PIC16C73A Rev. A Silicon Errata Sheet

The PIC16C73A (Rev. A) parts you have received conform functionally to the Device Data Sheet (DS30390E), except for the anomalies described below.

FIGURE 1: SCK PULSE VARIATION USING TIMER2/2

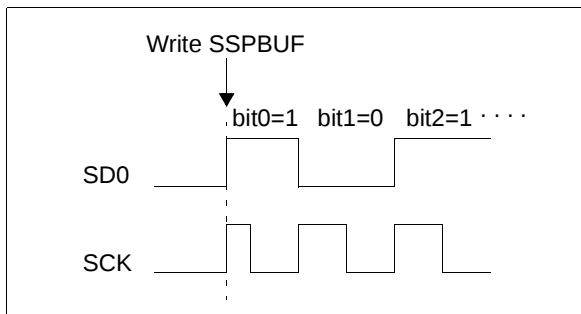
4. Module: SSP (SPI Mode)

When the SPI is using Timer2/2 as the clock source, a shorter than expected SCK pulse may occur on the first bit of the transmitted/received data (Figure 1).

To avoid producing the short pulse, turn off Timer2 and clear the TMR2 register, load the SSPBUF with the data to transmit, and then turn Timer2 back on. Refer to Example 1 for sample code.

FIGURE 1: WRITES TO TIMER1 (EXTERNAL CLOCK/OSCILLATOR MODE)

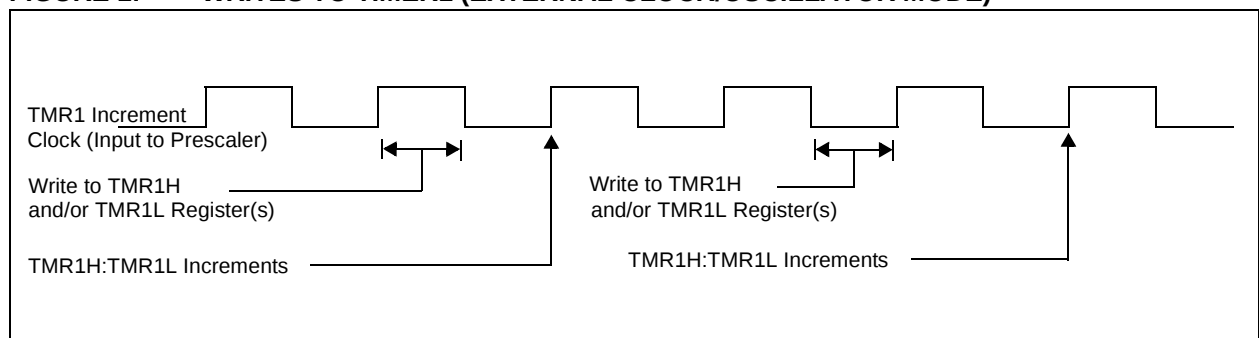
The operation of Timer1 needs some clarification when the timer registers are written when the TMR1ON bit is set.

The internal clock signal that is the input to the TMR1 prescaler affects the incrementing of Timer1 (TMR1H:TMR1L registers and the Timer1 prescaler). When the Timer1 registers are NOT written, the Timer1 will increment on the rising edge of the TMR1 increment clock.

When the TMR1H and/or TMR1L registers are written while this clock is high, TMR1 will increment on the next rising edge of this clock.

When the TMR1H and/or TMR1L registers are written while this clock is low, TMR1 will not increment on the next rising edge of this clock, but must first have a falling clock and the rising clock, for TMR1 to increment.

Figure 1 shows the two cases of writes to the TMR1H and/or TMR1L registers. Due to the V_{ih} and V_{il} thresholds on the oscillator/clock pins, external Timer1 oscillator components, and external clock frequency, the Timer1 increment clock may not be of a 50% duty cycle.

The TMR1 increment clock is out of phase of the T1OSO/T1CKI pin by a small propagation delay.
